# CITY OF PORTLAND

AT 42 Washington Ave 010854 EO15001

REASON FOR PERMIT: To Construct a 308 sq. ft. Attached deck

RE: 42 Washington Avenue – 013-E-015 - B-2b Zone

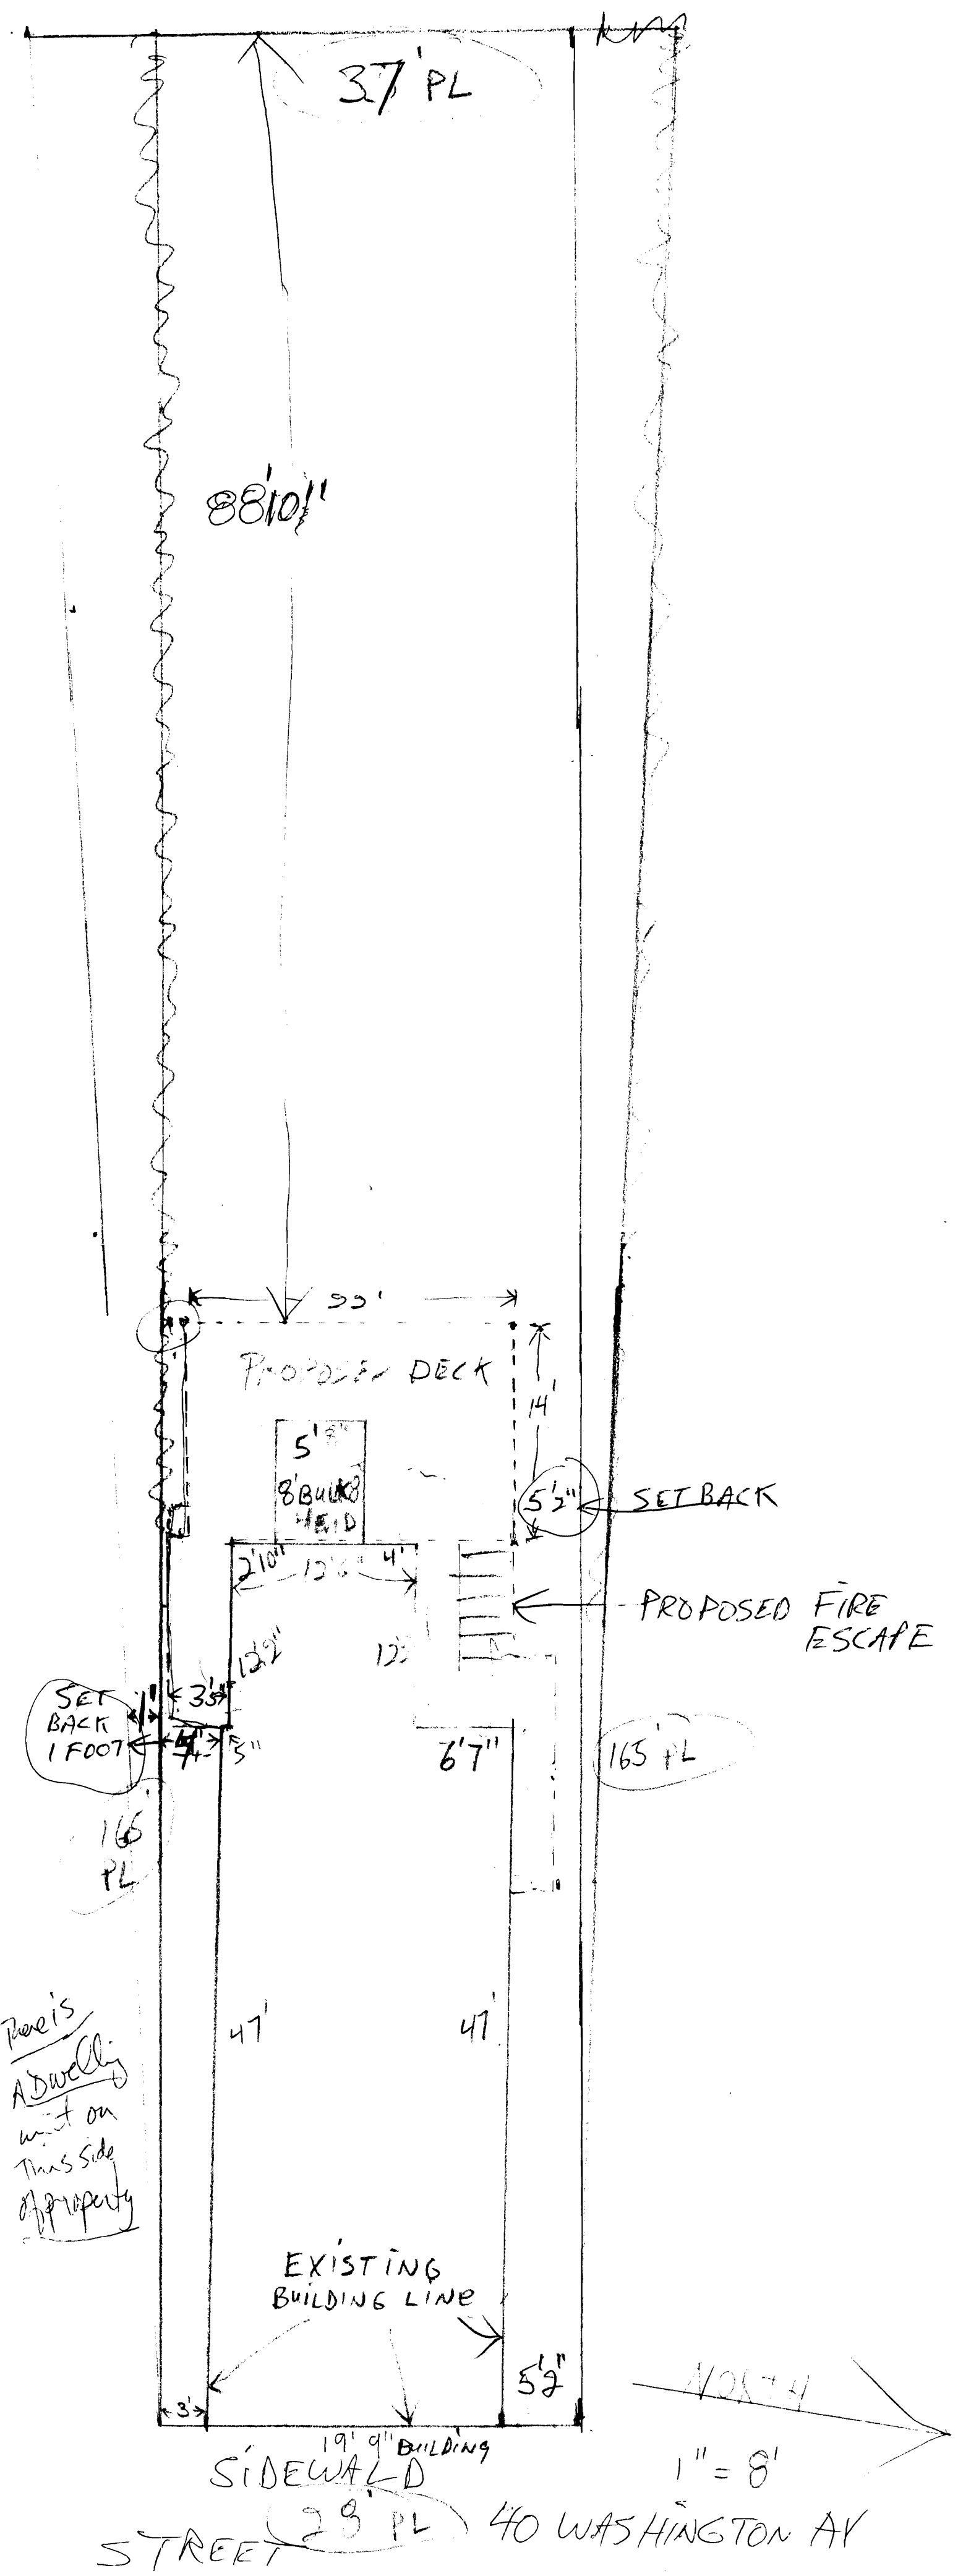
The B-2b Business zone states that there is no requirement for a setback from the property line except when the side line abuts a first floor residential zone or a residential use, then a ten (10) foot setback is required (section 14-185). The left hand side of your building abuts a first floor residential use. Your plans show that you have only a one (1) foot setback instead of the ten (10) foot setback required.

The zoning requirements also require off-street parking based on the increase square footage (section 14-332). Your submitted plot plan shows no increased parking for the new public deck. The ordinance requires 1 parking space for each 150 square feet of area. You would need to show this office at least 2 off-street parking spaces for this proposal.

Side Yard - Abuts a 1<sup>st</sup> floor residential use - 10' req - 1' shown

$14 \times 22 = 308 \div 150 = 2$  more of street parking

FRAMING SECTION A - 1/4" = 1'-0"

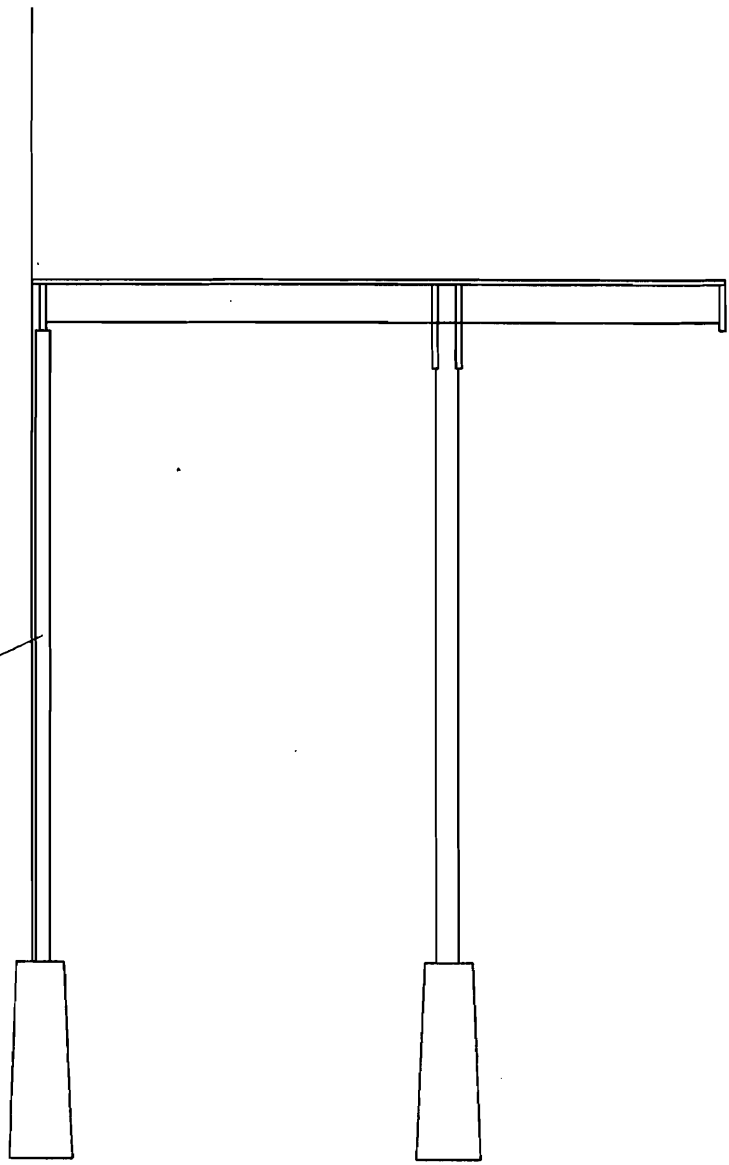
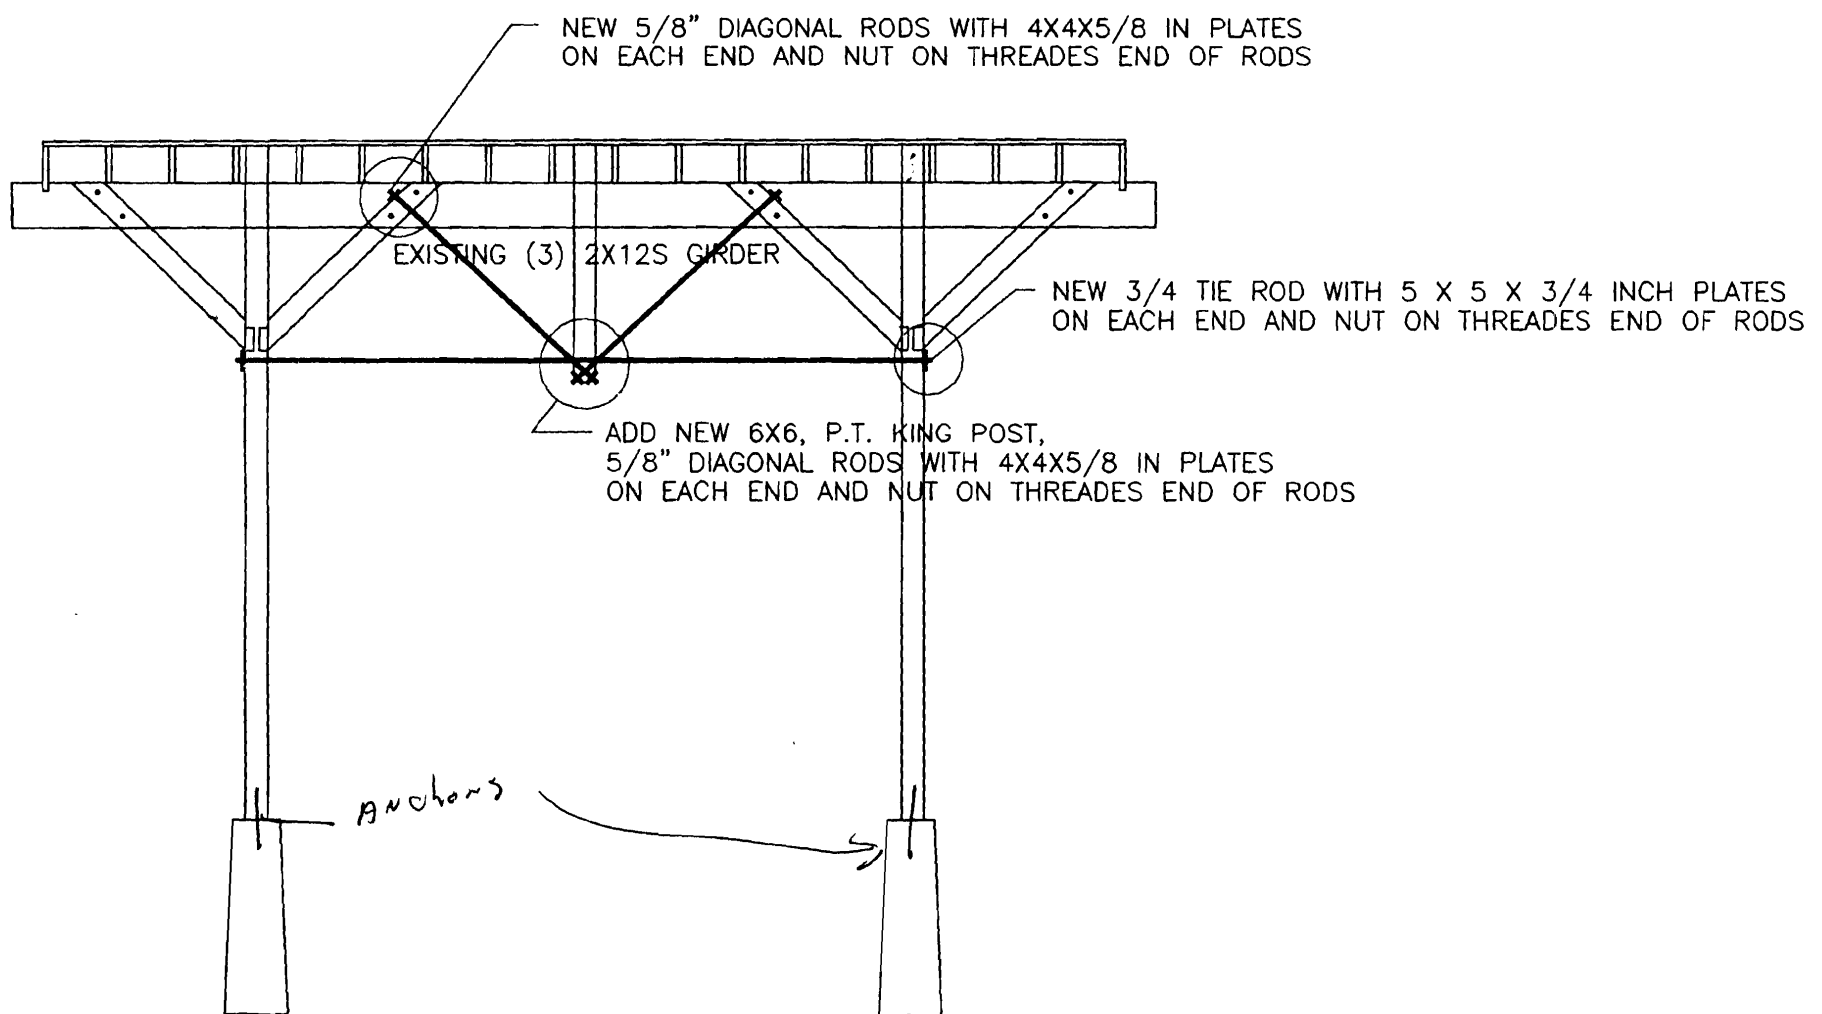
- \* 38. ~~The Columns shall be anchored to the foundation~~
- \* 39. ~~This permit is for the deck only - Not the fire escape -~~
- \* 40. ~~This permit is issued for private use only - IF public is to use the deck - you shall submit plans design by a professional engineer - Received design by prof. 609 on 18/July/10/08~~

- \* 41. ~~IF deck is part of fire escape system a new permit shall be applied for showing a detail of stairs -~~
